“Impacts to the AP1000 DCD to Address Generic Safety Issue (GSI)-191”

TITLE: Impacts to the AP1000 DCD to Address Generic Safety Issue (GSI)-191

AP1000 DCD Impact Document

Revision 1 of this document is created to address two items. The first item is the addition of flanges to the lines L113B and L131B as shown on page 25 of this document. Second is a change to the material that encloses the excore detectors. Due to design evolution, the materials the excore detector enclosures can be made of now include stainless steel and titanium.

Figure 2.2.3-1 (Sheet 2 of 2)
 Passive Core Cooling System

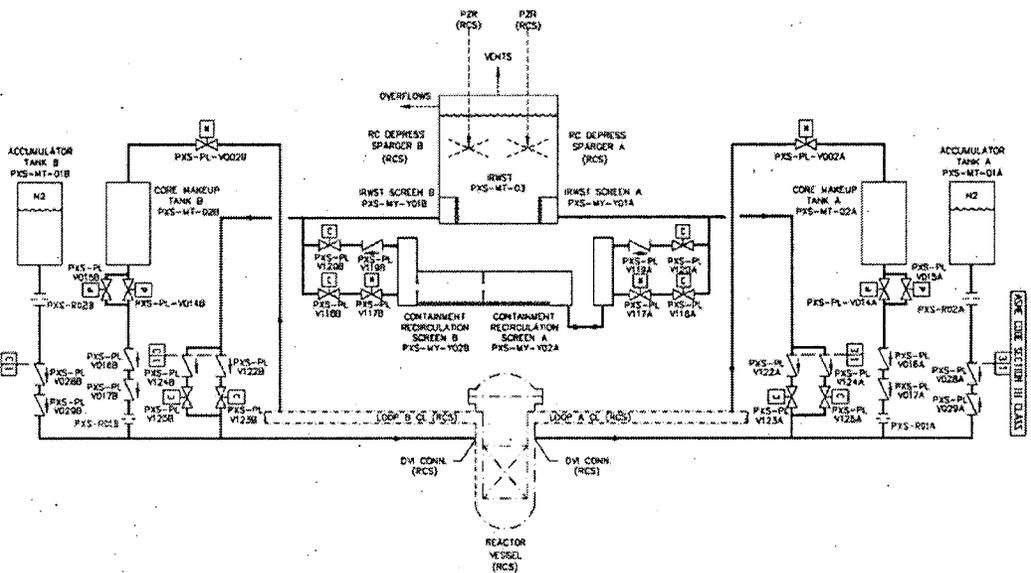
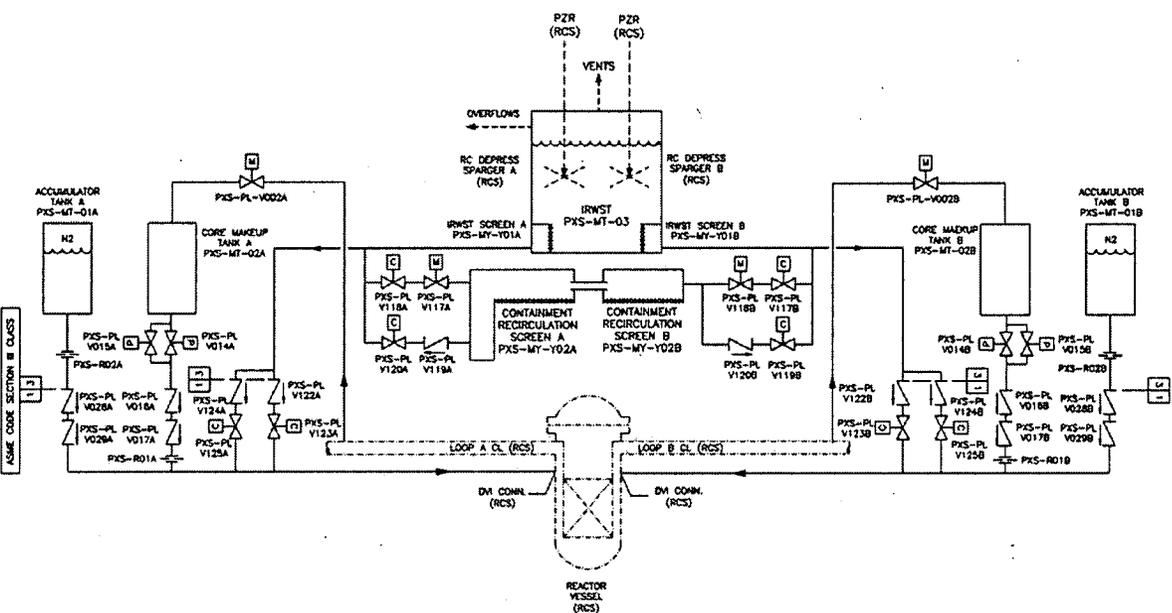
Justification for changes to Figure 2.2.3-1 (Sheet 2 of 2): The screens are now separated by a flow channel and on inspection it was noticed that the A and B components were flipped on this figure. Previously, when the system was symmetric, this was not an issue; however, with the addition of the flow channel, the A and B components were flipped to match Figure 6.3-2 (Sheet 2 of 2) to avoid a Human Factors Error.

Figure 6.3-6

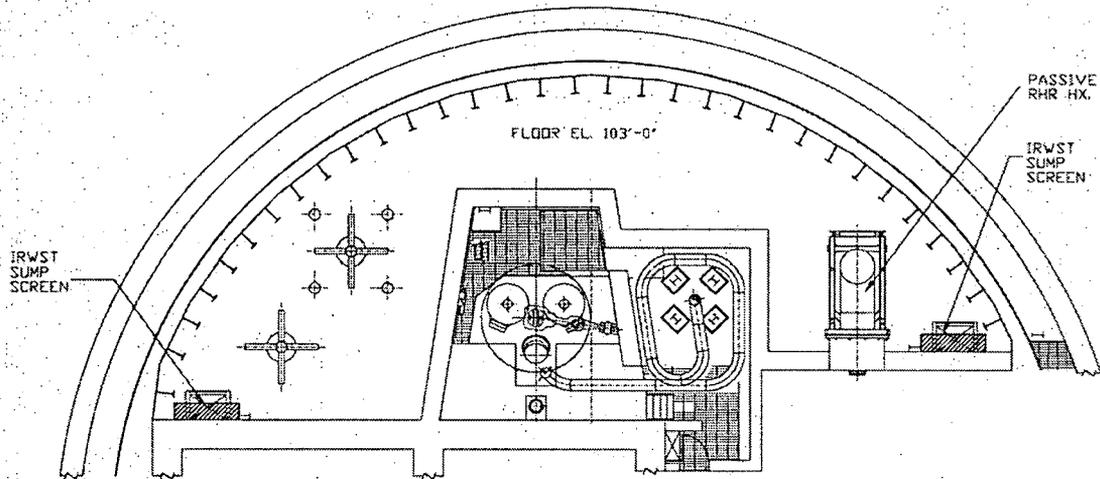
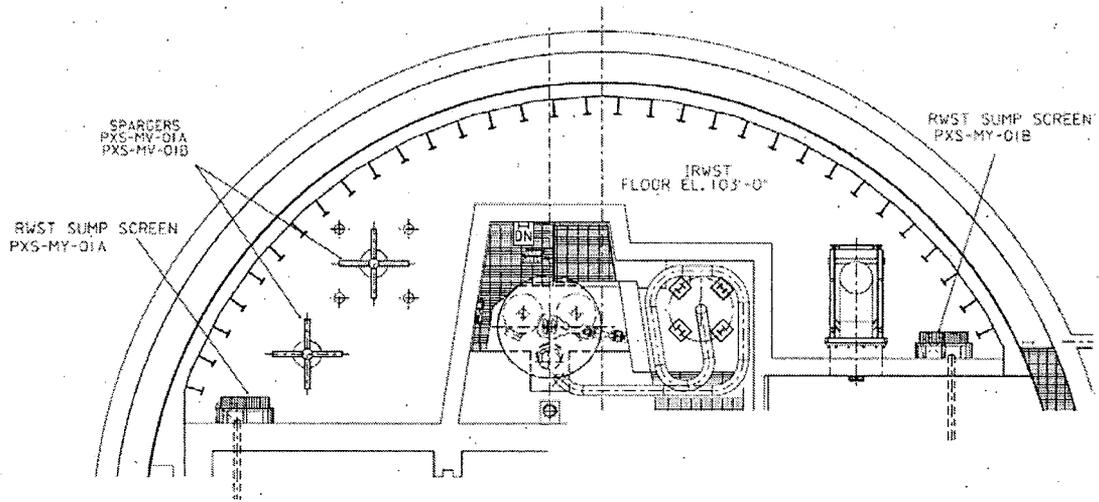
Justification for changes to Figure 6.3-6: The figure is changed to show the revised location of the IRWST screens.

Figure 6.3-8

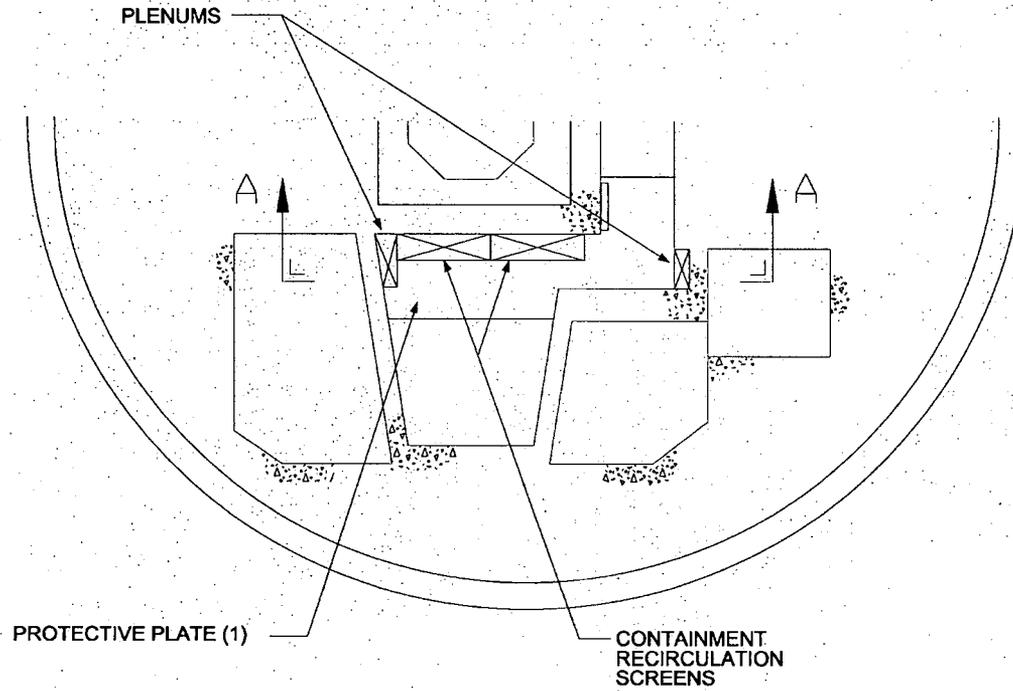
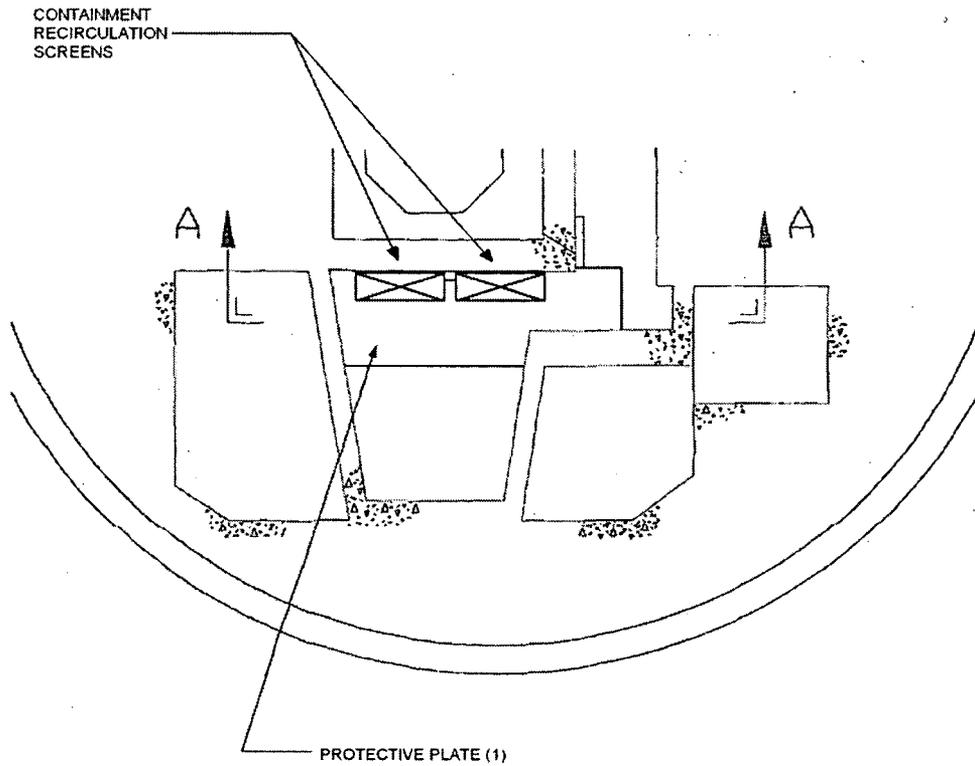
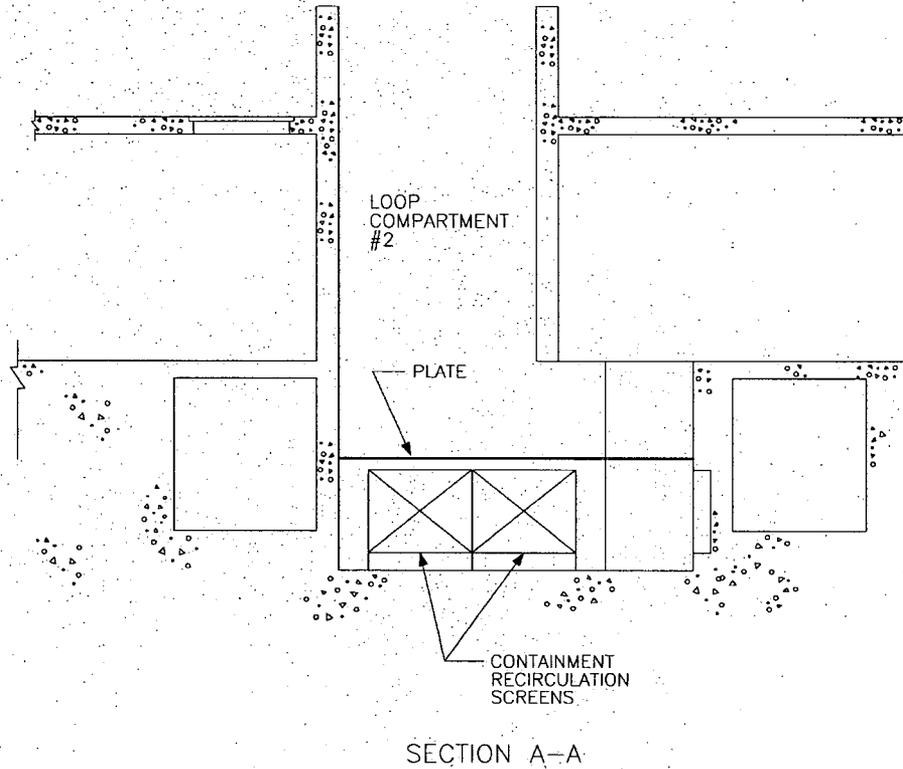
Justification for changes to Figure 6.3-8: The figure is changed to show the revised screen design defined in Reference 3.

Figure 6.3-9

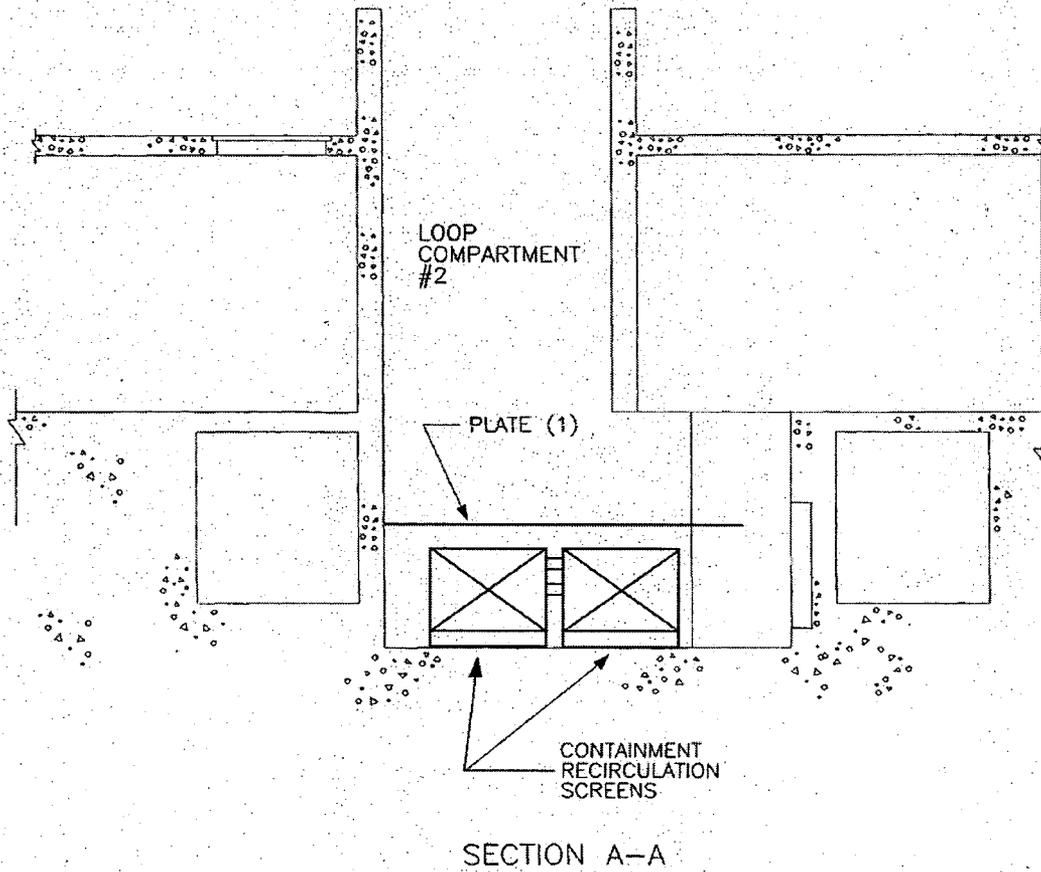
Justification for changes to Figure 6.3-9: The figure is changed to show the revised screen design defined in Reference 3.
